City Commission Site Plan Review

SP-14-00525: Site Plan for Cedarwood Senior Cottages, located at 2525 Cedarwood Ave. The facility will consist of 7 duplex dwellings and a community building. Submitted by Grob Engineering Services, LLC for Douglas County, property owner of record.

Figure 3. Alternative compliance for bufferyard requirement. Area of request circled.

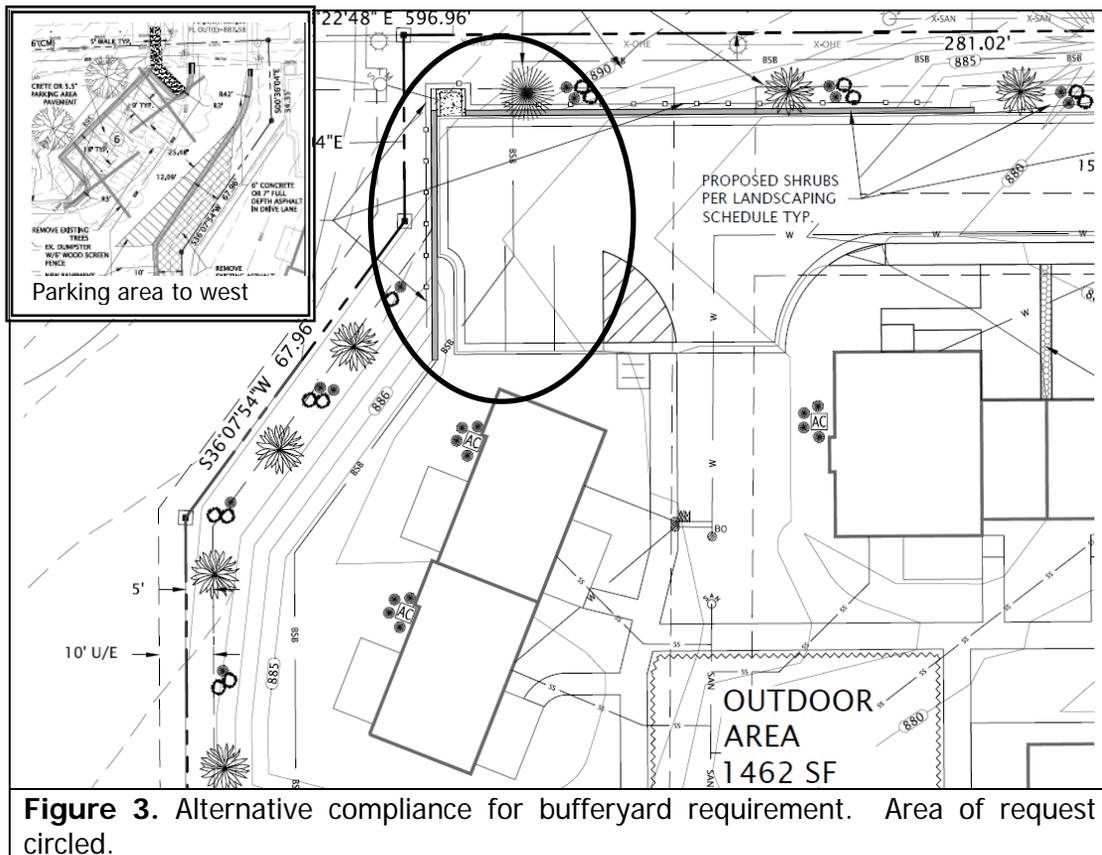
The site plan provides the required parking and landscaping. Alternative Compliance from the bufferyard requirement along the west property line (separating the property with the United Way property) has been requested to allow the placement of a 3 ft high double sided wood fence along the west side of the buffer area where the required buffer width isn't provided. The fencing would provide adequate buffering, in staff's opinion, based on the fact that parking areas are adjacent to each other in this area. The wood fencing would extend along a portion of the north side of the access drive. A fence is required in this area due to the height of the retaining wall and the wood fence would provide a buffer for the property owner to the north. (Figure 3)

The site plan, as conditioned, and with the approval of Alternative Compliance for the north 58ft of the west bufferyard area, is compliant with the Development Code.

Figure 4. Vehicle and pedestrian circulation. (Access drives are shaded.)

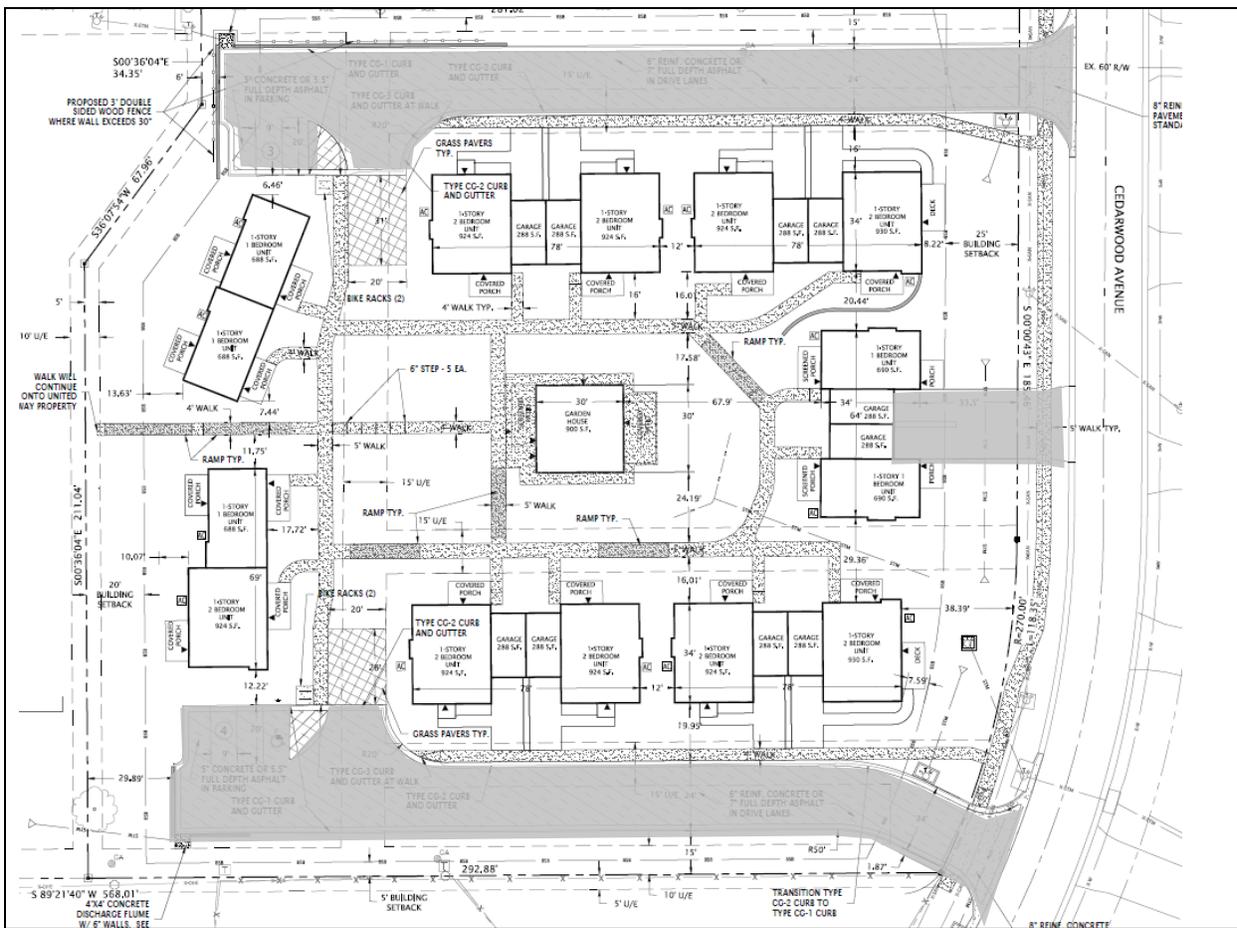
As noted earlier, the development will take access to Cedarwood Avenue with access drives on the north and south side of the property. In addition the duplex facing Cedarwood Avenue will have direct access to the street, similar to other residences in the area. Each access drive will terminate in a turnaround area for fire trucks. (Figure 4)

The site plan provides for the safe movement of pedestrians within the site with walkways along each access drive and connecting walks to the dwelling units. In addition, walkways have been provided in the interior of the site connecting the dwellings to the community building and to the United Way Building to the west. The walkways provide good connectivity throughout the site and provide a recreational feature as well.
